SERVICE PROCEDURE

**G-08507
AUGUST 2008**

**SUBJECT: SAFETY RECALL (U.S.)
ENGINE HIGH PRESSURE OIL LINE ASSEMBLIES
on certain IC Bus RE models built 1/3/96 thru
3/22/04 with an INTERNATIONAL® T444E engine.**

Figure A
8900200R91 – Older Style

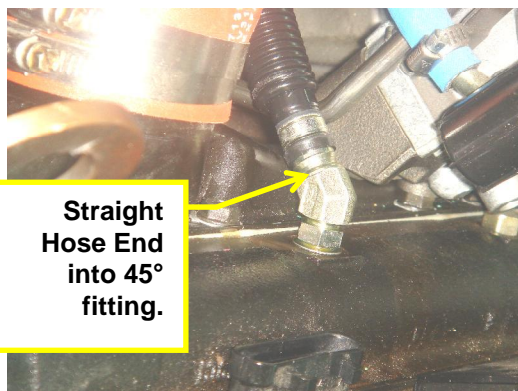
Inspect the high pressure hose fitting located on the driver's side of the engine valley. Some vehicles may be equipped with an older style right bank hose assemblies.

If the hose assembly fitting looks like Figure A: use kit 8900200R91.

Figure B
8900201R91 – Newer Style

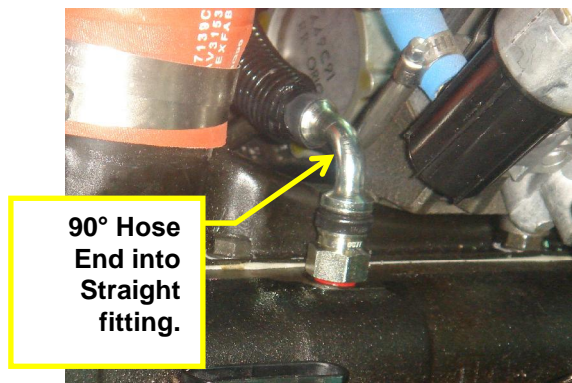
If the hose assembly fitting looks like Figure B: use kit 8900201R91.
